CHANGE ORDER NUMBER: 21

Contract Award Date:	9/13/2022
Project Number:	22IFB139
Funding Source:	P332
Roadway:	FM 3349
CSJ Number:	3486-01-008

**FM3349 at US 79
Williamson County Project No. 22IFB139**

Change Order No. 21

ELEVATION DETAIL
Long Span Guardrail

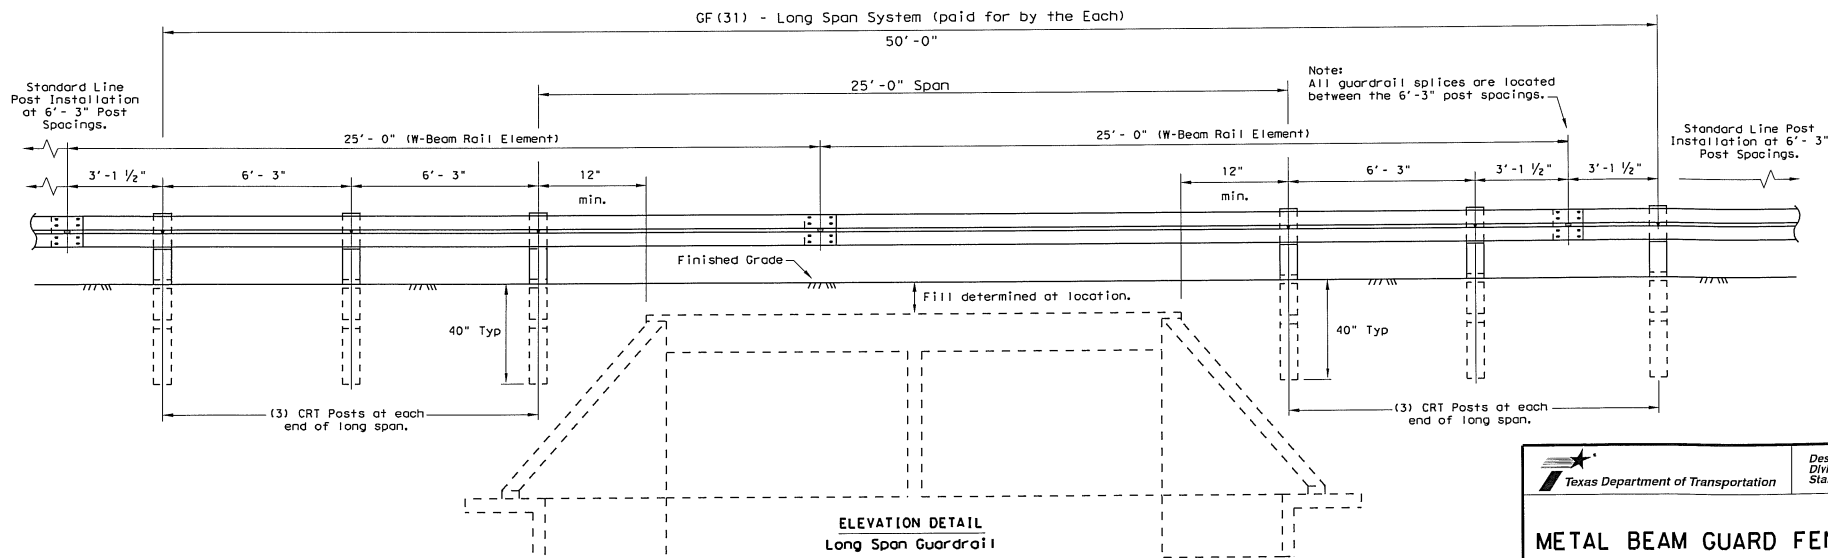
This Change Order compensates the Contractor for installing long-span metal beam guard fence in the project. At several locations on south bound frontage road (SBFR), the backless concrete inlets conflict with the location of the wooden posts supporting the metal beam guard fence (MBGF) runs. These conflicts were reviewed by the Engineer of Record, and it was recommended to utilize the TxDOT standard long-span MBGF to clear the conflicts. This solution has been agreed to by TxDOT.

ITEM	DESCRIPTION	QTY	UNIT
540 6017	MTL W-BEAM GD FEN (Long Span System)	100	LF
540 6020	MTL BM W- Beam GD Fence (Low Fill Culvert)	50	LF
